2207 College Street

DESIGN/DEVELOPMENT REVIEW COMMISSION
DESIGN REVIEW DISTRICT
HISTORIC AGENDA
EVALUATION SHEET
Case # 11

ADDRESS: 2207 College Street

NATURE OF REQUEST: Request Certificate of Design Approval for new construction

LEFT SIDE EXTERIOR ELEVATION

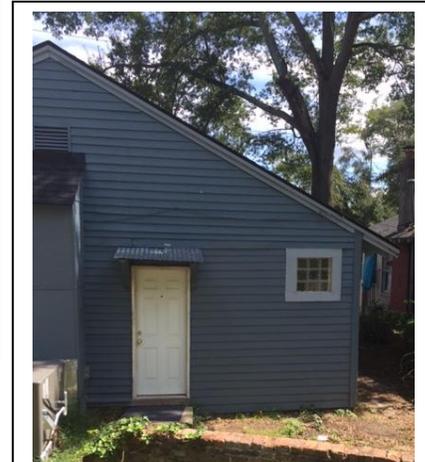
On the proposed west (left) elevation, the original proposal included a single, diamond-shaped window on the first floor and a single, small, vertical window almost centrally located on the second floor. The latest submittal added a small vertical window to the first floor and one full size vertical window to the upper floor. This gives the left side a total of one full size window, two small windows, and a diamond-shaped window. The location and diminutive size of three of the windows leaves a large amount of wall space in relationship to voids and the massing is inconsistent with historic buildings. The adjacent two buildings have side walls that are approximately 34 feet long, so they are somewhat comparable to the 37' length of the proposed building. Their massing is broken up into two wide bays, delineated by the alignment of full-size, vertical windows on both floors.

- Setback of the house shall be in line with adjacent houses
- The fenestration on the left side elevation shall be revised to include one additional full-size window near the front on the second floor, and replacement of the diamond window with a

- full-size rectangular window on the first floor that is compatible with historic buildings, and with a consistent 3/1 pane configuration throughout
- The fenestration on the right side elevation shall be revised to remove the transom window on the second floor and the wide horizontal three-lite window on the first floor; that two full size, vertical, rectangular windows will be added on the first floor in an appearance and pattern consistent with historic buildings

Staff changes to updated drawing from applicant

RIGHT SIDE EXTERIOR ELEVATION

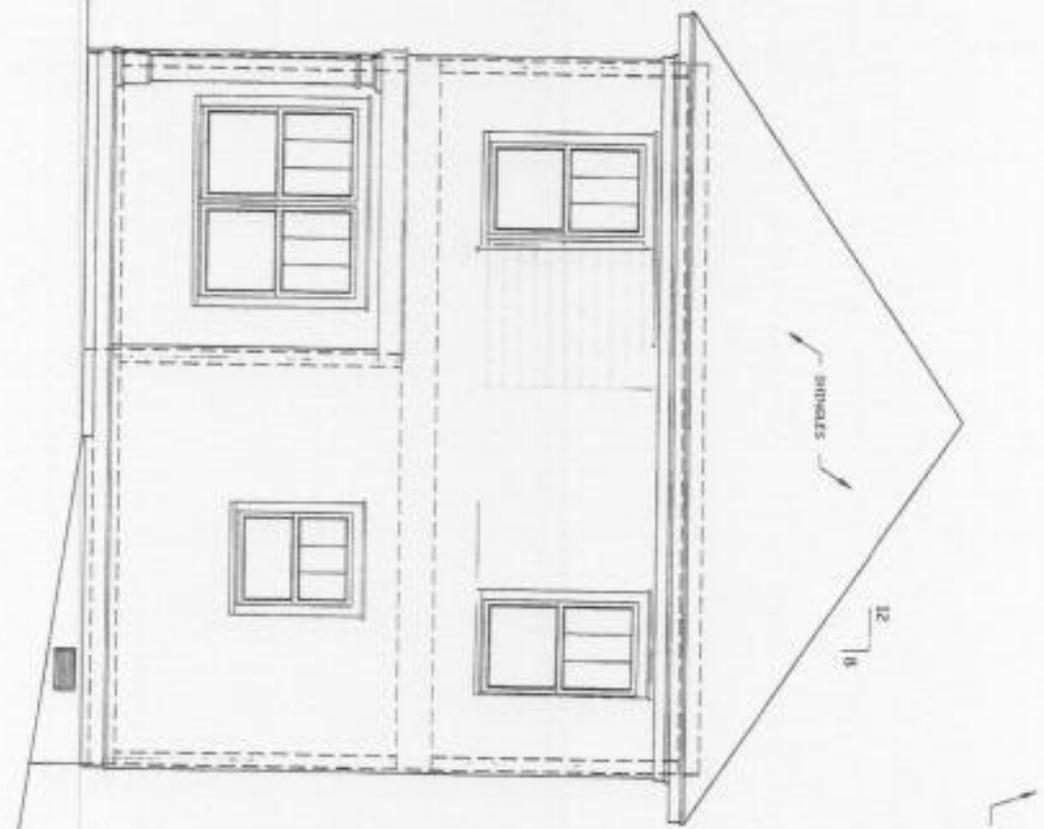
A similar inconsistency with massing is on the east (right) side of the proposed building. The original drawing showed a small undersized vertical window and a horizontal transom window on the second floor, with a single, full size vertical window on the first floor. The latest drawing adds a full size window to the second floor but removes the full size vertical window on the first floor and instead introduces an overly large transom-style, horizontal three-lite row of windows, unlike anything seen on the block or street, or the entire district. This change has diminished the wall's ability to be compatible with the massing of existing historic buildings as it has created a large volume of wall space on the right side.

The proposed horizontal transom windows on the east (right) side, both small and large, have no precedent on historic buildings in the area. Likewise, the diamond-shaped window does not meet the guideline. While it may be a feature found on houses of a similar form or style in other areas of Columbia, the guidelines specifically address examples that are found within the block or street. This is an important component of the guidelines that recognizes the local influences unique to each neighborhood and maintains a continuity of details that were generated within a confined area, and which help distinguish neighborhoods from each other.

Proposed driveway position. (A)

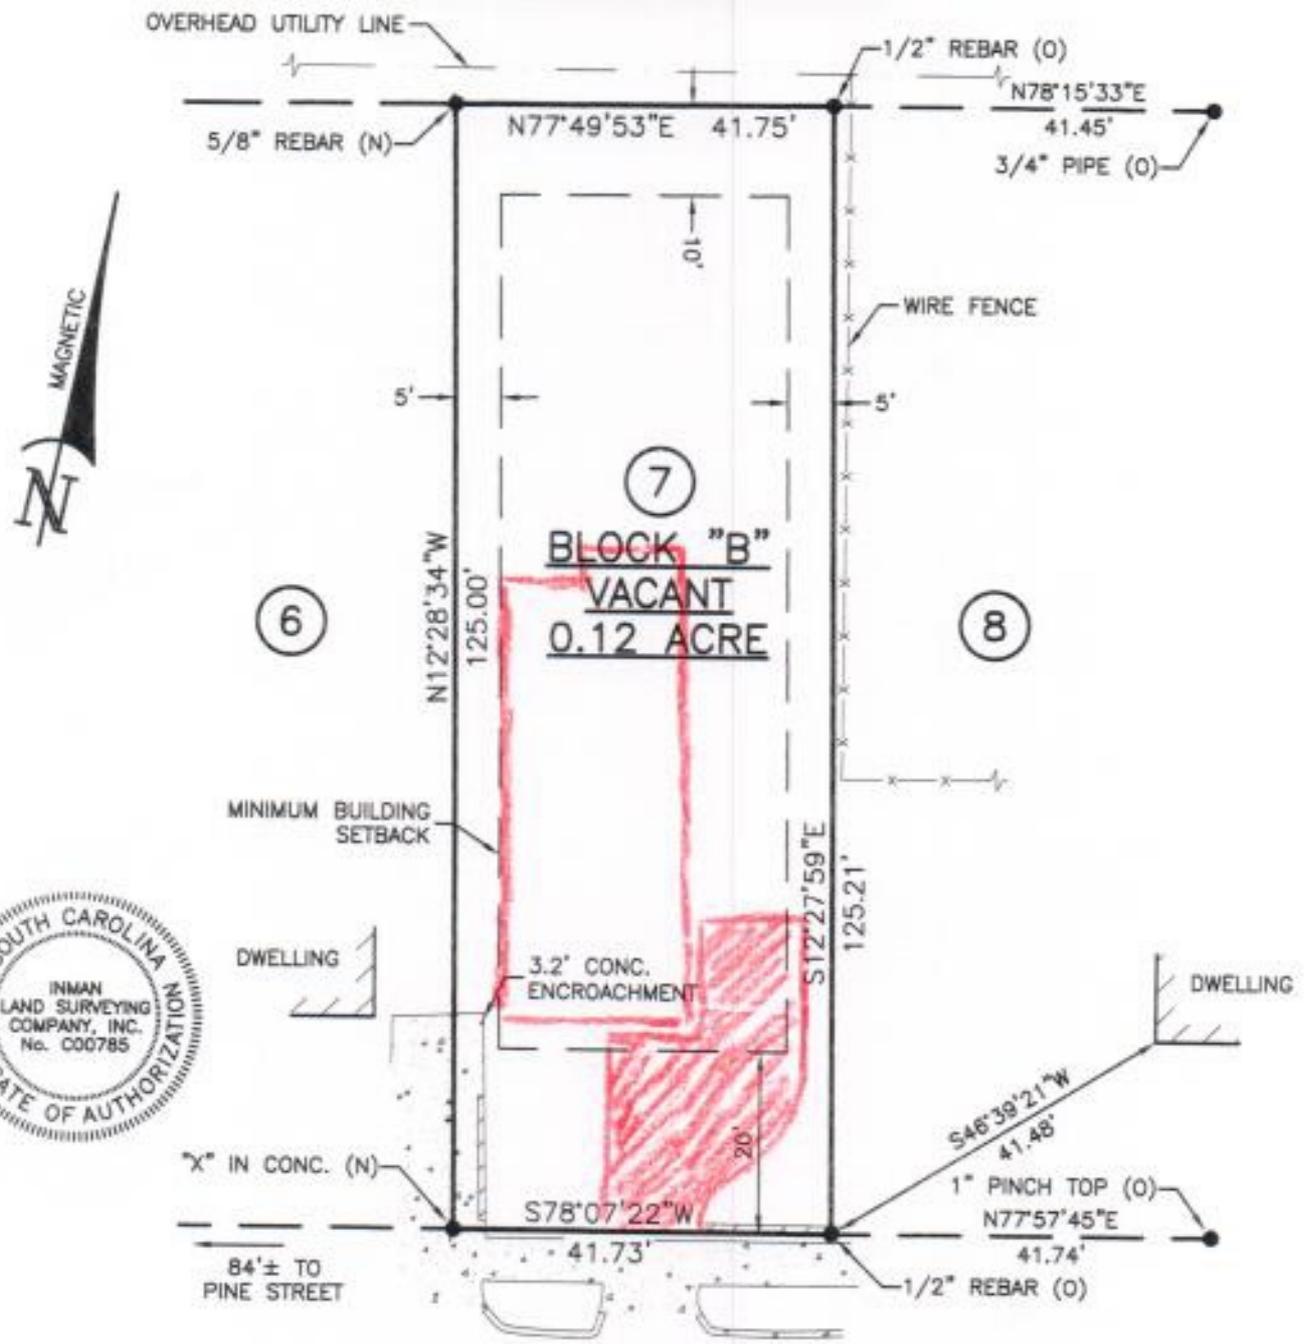
street parking spaces. Two options have been supplied for the driveway on an attached diagram, option A and B. An existing curb cut is almost centrally located on the lot, with a mature City tree to the left of the curb cut. The proposed Option A has the driveway curving to the left of the house from the cut, which is preferable to Option B, which is much wider than what is allowed and places parking directly in front of the house.

No dimensions have been provided but staff will review a site plan before issuing a final approval. Due to the existing curb cut and existing City trees the driveway may have to curve, but staff can contact City Forestry to determine if the trees are healthy. If they are and a relocated curb cut would compromise the trees then Option A by the applicant is a closer match to this ordinance.

Option A is not ideal in that the driveway is entering the lot directly in front of the house, but if the current curb cut needs to remain then it is preferable to Option B.

- That the driveway design first attempt to meet the city ordinance with a straight driveway and curb cut but if City Forestry staff determine the trees should stay then Option A of the submitted driveway will be used, with further details about width, length and materials worked out with staff
